Remarks

Attorney Docket No. LUKP:123US
U.S. Patent Application No. 10/711,823
Reply to Office Action of April 19, 2006
Date: July 14 2006

Fig. 2

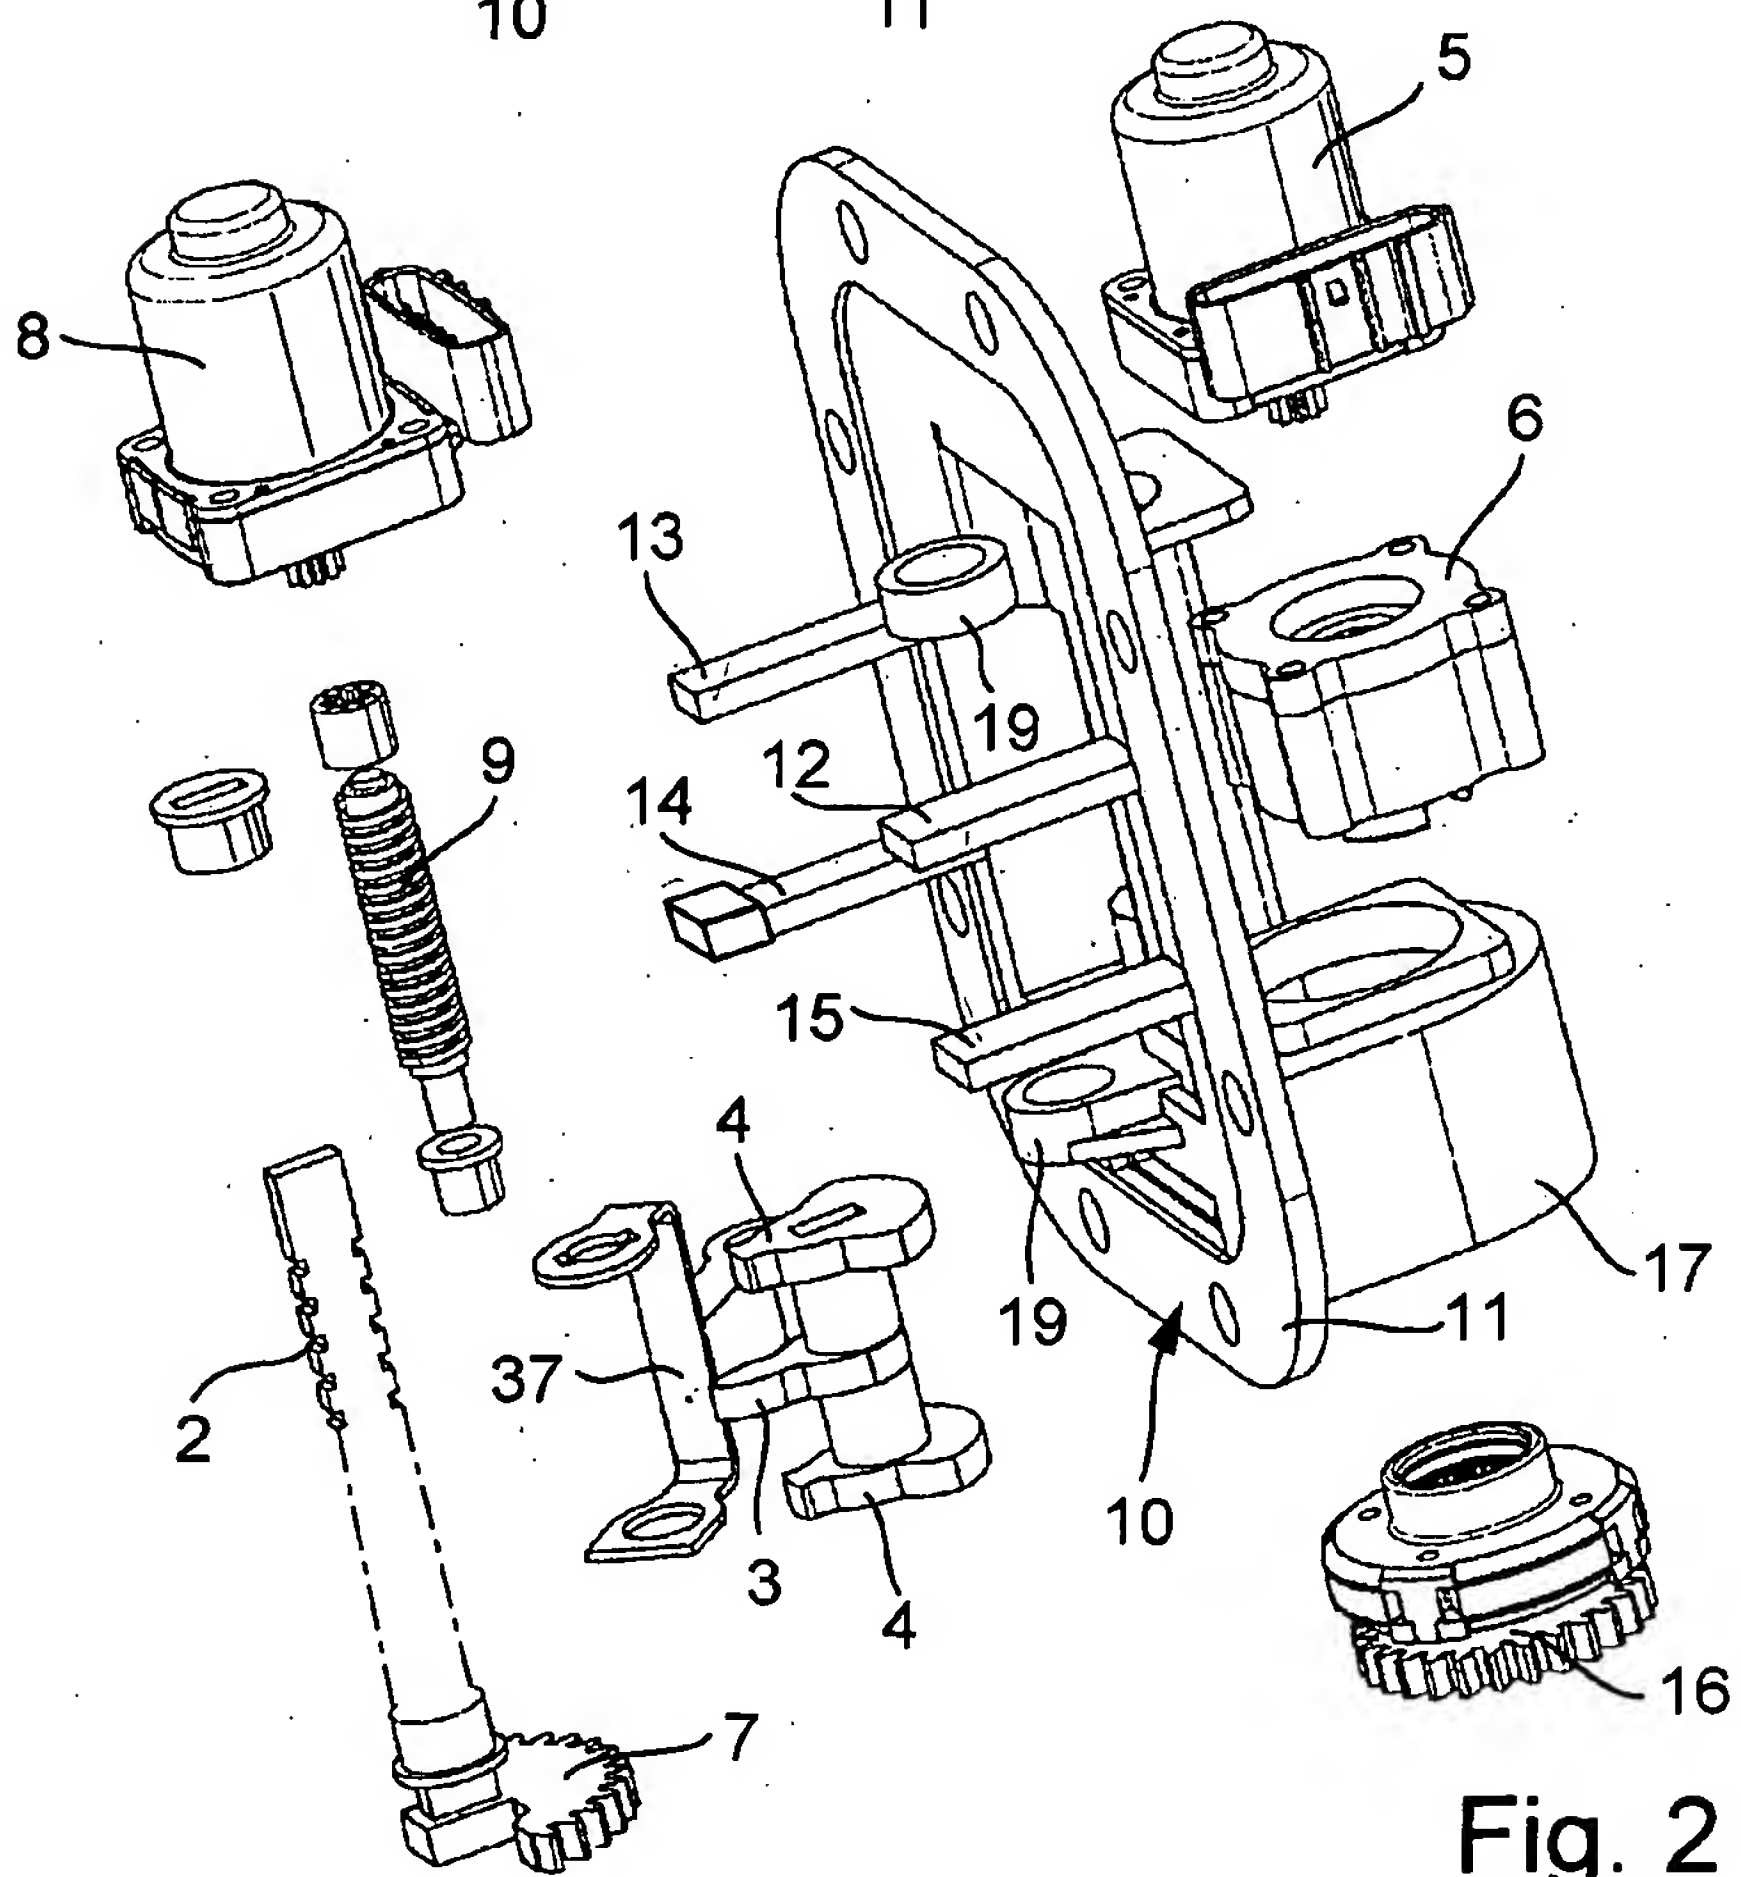
The Examiner objected under 35 U.S.C. § 132 (a) to the amendment to the specification entered in the Reply dated February 1, 2006 as introducing new matter into the disclosure. The Examiner stated two grounds for this objection – with respect to the amended drawing of the guide shoes and with respect to the structural limitations of the term “jib”.

With regard to the objection to the amended drawing of the guide shoes, Applicants respectfully traverse this objection and request reconsideration. As mentioned in the previous Reply, the drawing of Figure 2 was amended to add the three additional guide shoe parts 38 that were claimed in Claim 8. The guide shoe parts were originally described in paragraph 0013 of the original specification as “...arranged at the ends of jibs 12 to 15 on the contact surfaces toward the gearshift rails, which guide shoe parts are made of plastic and can be clipped on. Such a guide shoe part is illustrated in the form of a diagram in Figure 2 and is labeled 38.” As noted in the previous Reply, only one guide shoe part on jib 14 was depicted in Figure 2 of the original drawings and it was not labeled. (See Appendix I showing original drawing of Figure 2.) In amended Figure 2, shown in Appendix II, the remaining three guide shoe parts were depicted on the ends of jibs 12, 13, and 15 as described in paragraph 0013 of the original specification and were labeled with reference no. 38.

Applicants respectfully submit that Figure 2, both as originally filed and as amended, depicts the embodiment claimed in Claim 7 in which two protruding rods at a time are symmetrically opposite each other with respect to the selector shaft. Applicants respectfully point out that the upper pair of protruding rods **12** and **13** and lower pair of protruding rods **14** and **15** are symmetrically opposite from each other as related to selector shaft **2** as each member of both the upper and lower pairs are the same distance from the selector shaft and each plane formed together by each of the upper and lower pairs are both parallel to the upper and lower sides of the attachment part **11**. This configuration per force makes the two pairs symmetrical as

MPEP § 2163.06 states that “information contained in any one of the specification, claims, or drawings of the application as filed may be added to any other part of the application without introducing new matter.” Applicants respectfully submit that the description of the guide shoe parts as “arranged at the ends of jibs 12 to 15” accurately describes the position of the guide shoe parts as shown in amended Figure 2. The jibs themselves are labeled and described in paragraph 0013 of the original specification as “... comprises two upper jibs 12, 13 as well as two lower jibs 14, 15 that preferably protrude from attachment part 11 into the gear and that between themselves guide and support the packet of gearshift rails.” The jibs are seen as protruding from attachment part 11 in original Figure 2 and additionally, original Figure 2 also shows one guide shoe part. Original Claim 8 also describes guide shoe parts at the ends of the

jibs. Therefore, because all of the guide shoe parts were described as to location in the original specification and one guide shoe part was shown in the described position at the end of a jib, Applicants respectfully submit the guide shoe parts were described in the original application as filed. Consequently, the depiction of guide shoe parts at the end of each jib in amended Figure 2 does not introduce new matter. Applicants respectfully request reconsideration and the withdrawal of the new matter objection to amended Figure 2.
